# 8850 Sunset Boulevard Project Final Environmental Impact Report

State Clearinghouse No. 2019090447

Final Environmental Impact Report

**Chapter 2 – Response to Comments.** During the public review period for the Draft EIR, written comment letters were received by the City and oral testimony was provided at public meetings. This chapter contains these comment letters, a summary of the oral testimony, and the City’s responses to the comments.

**FL 08**

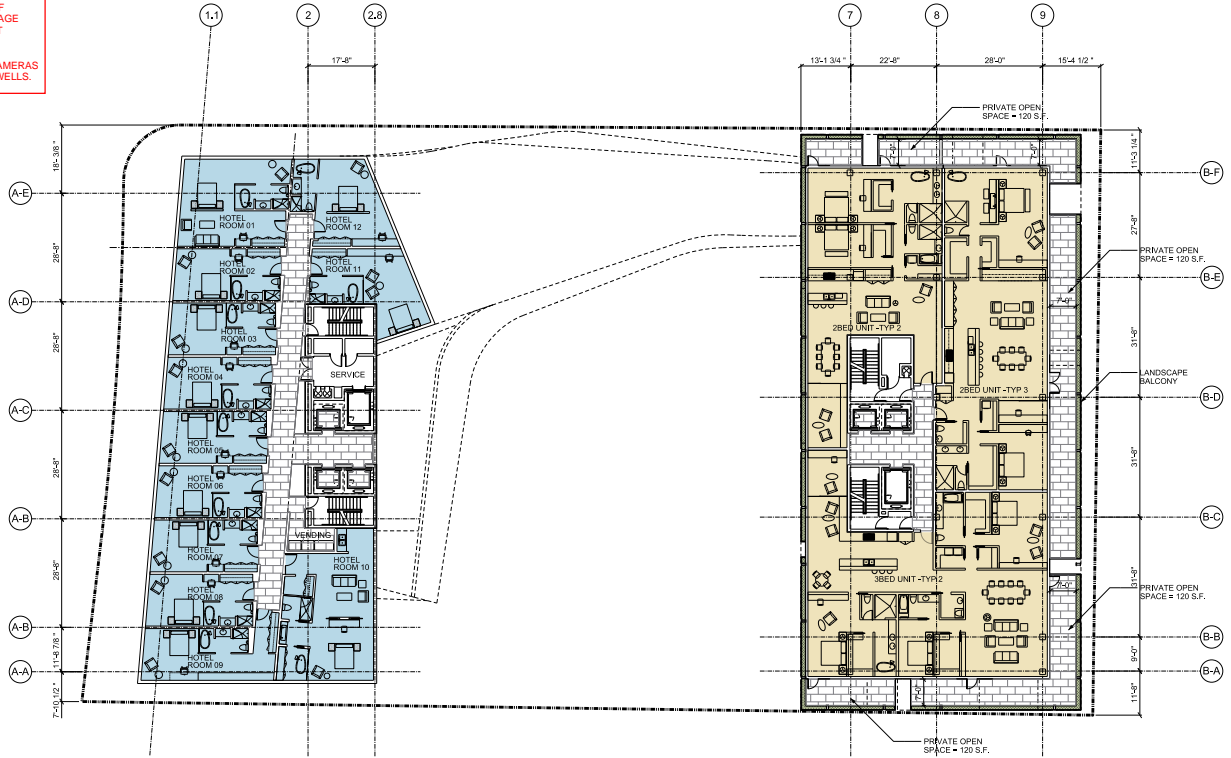
1. RECOMMEND TO CLEARLY IDENTIFY THE ACCESSIBLE AND EMERGENCY ROUTE OF TRAVEL WITH DISCERNABLE ROOM SIGNAGE WALL AND ILLUMINATED EXIT SIGNS, EXIT STAIRS SIGNS, AND ADA TOILET SIGNS.
2. RECOMMEND PROVIDING SECURITY CAMERAS AT ENTRY/EXIT, ELEVATORS, AND STAIRWELLS.

**A2-8** This comment consists of design recommendations from the Sheriff's Department related to the provision of security cameras and other design features aimed at improving site security. These recommendations will be included in the Final EIR for review and consideration by decision makers. Additionally, the project applicant has agreed to implement recommendations provided in the comment to the extent applicable to and feasible for the project as approved by the City, including spike strips, surveillance, and adequate lighting.

**FL 11**

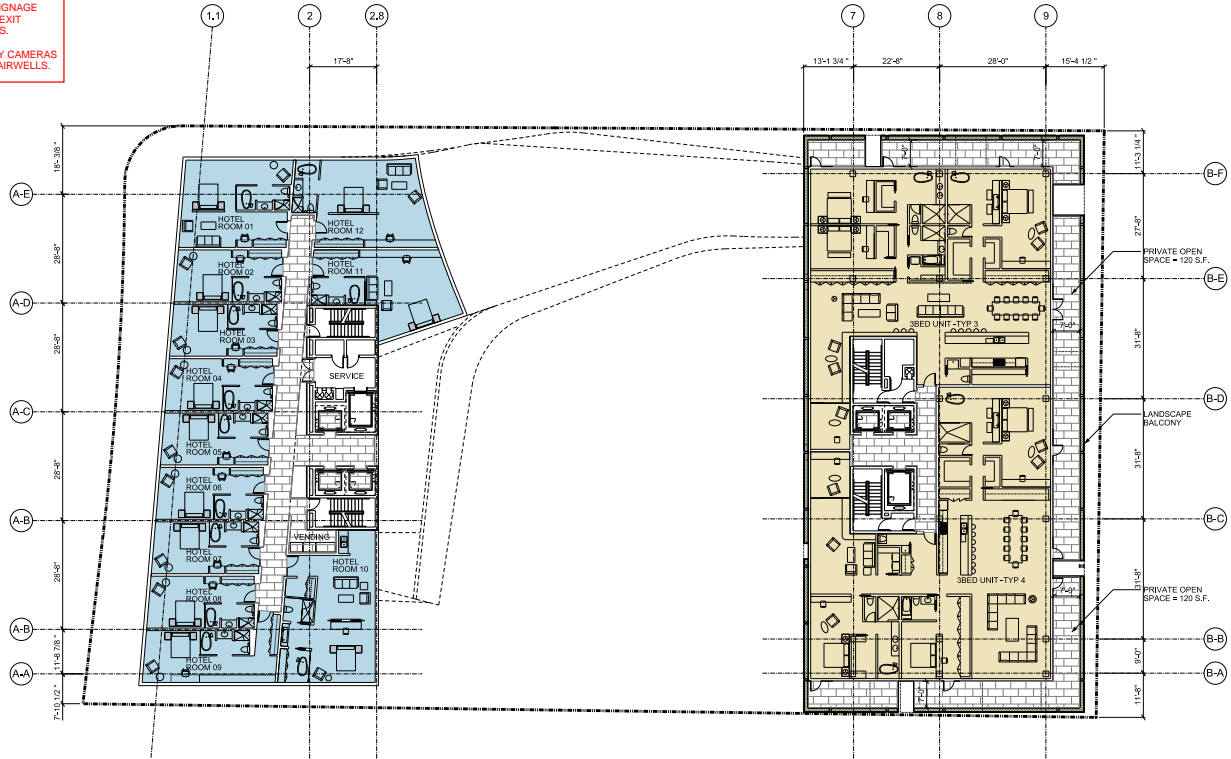
1. RECOMMEND TO CLEARLY IDENTIFY THE ACCESSIBLE AND EMERGENCY ROUTE OF TRAVEL WITH DISCERNABLE ROOM SIGNAGE WALL AND ILLUMINATED EXIT SIGNS, EXIT STAIRS SIGNS, AND ADA TOILET SIGNS.
2. RECOMMEND PROVIDING SECURITY CAMERAS AT ENTRY/EXIT, ELEVATORS, AND STAIRWELLS.

**FL 14**

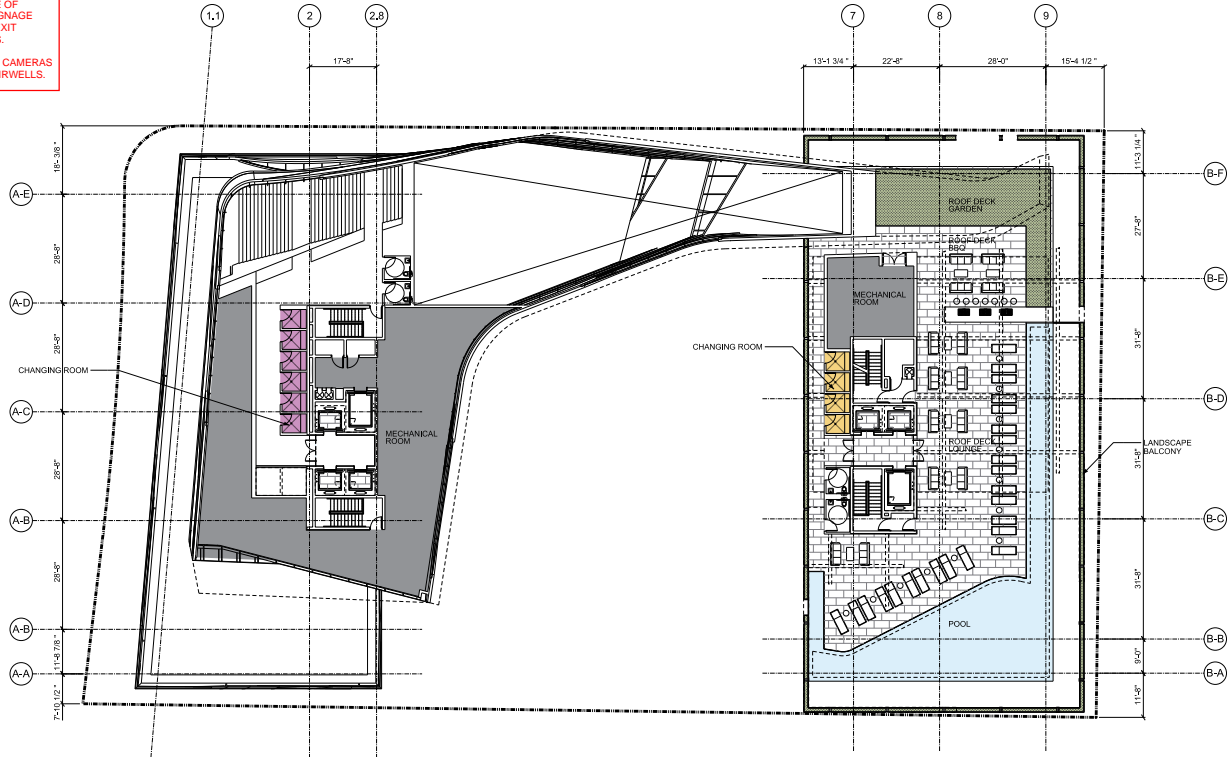
1. RECOMMEND TO CLEARLY IDENTIFY THE ACCESSIBLE AND EMERGENCY ROUTE OF TRAVEL WITH DISCERNABLE ROOM SIGNAGE WALL AND ILLUMINATED EXIT SIGNS, EXIT STAIRS SIGNS, AND ADA TOILET SIGNS.
2. RECOMMEND PROVIDING SECURITY CAMERAS AT ENTRY/EXIT, ELEVATORS, AND STAIRWELLS.
